South West Milton Keynes

Stage 1 Road Safety Audit

Designer's response to Stage 1 Road Safety
Audit

Project Title	Land South of A421, South West Milton Keynes
Report Title	Designer's response to Stage 1 Road Safety Audit: Access Junctions
Revision	01a
Status	Final
Control Date	17th December 2015

Figure 1: Suggested relocation of crossing point

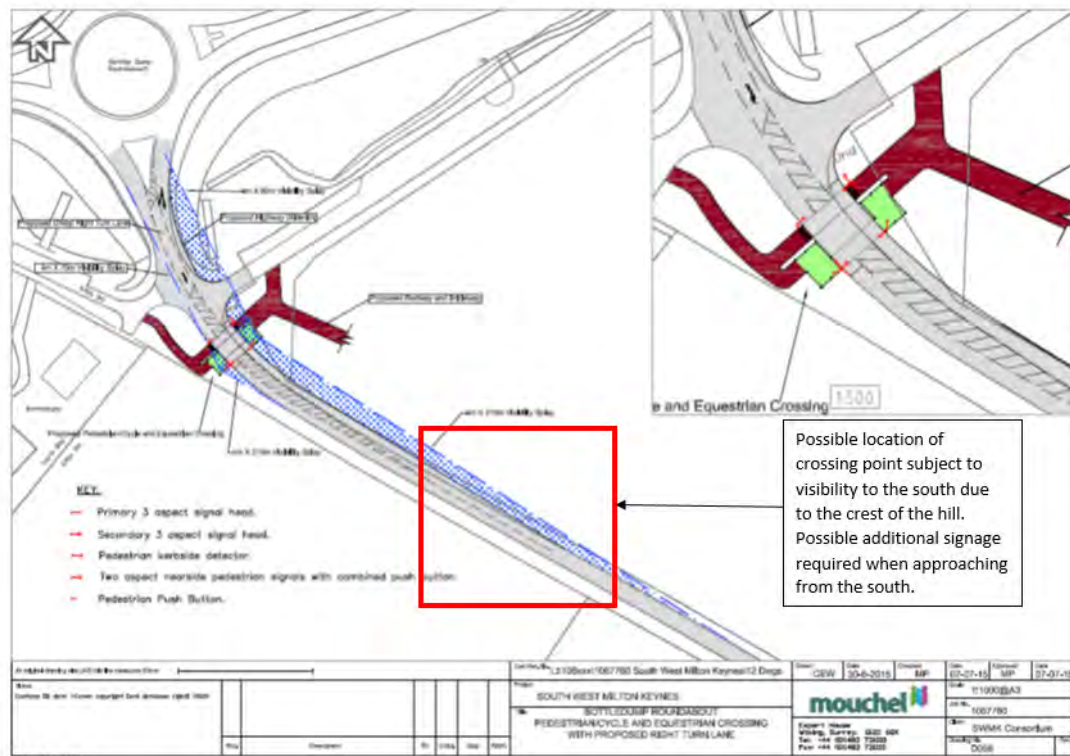
Detail: The audit team are concerned of the proposed location of the new Pegasus crossing on Whaddon Road. Site observations highlighted two existing accesses to the north of the proposed location, which itself is on a bend. In addition the design proposes a ghost right turn island immediately to the south of Bottle Dump Roundabout into the recycling centre. Site observations also highlighted high vehicle speeds, in particular from exiting the roundabout onto Whaddon Road. There is a risk that vehicles exiting the roundabout will be faced with too much activity with a very short distance prior to the crossing, which in turn could take their awareness off the approaching crossing which could lead to heavy/late braking resulting in rear end shunt collisions or potential of NMU / vehicular conflicts.

- 2.1 Noted. Following further discussions with the Audit Team, the diagram in Figure 1 was provided as a guide to an acceptable relocation for the crossing point.

- 2.2 The equestrian/pedestrian/cyclist crossing has been relocated further south along Whaddon Road, as shown in Drawing D015B, broadly in line with Figure 1. The ghosted right turn into Pearce Recycling has been removed from the design as there is no longer an interaction between horses crossing and HGVs turning at this location. The relocated crossing point provides a sight stopping distance (SSD) in excess of 154m to the Bottle Dump Roundabout exit to the north, and 154m to the south.
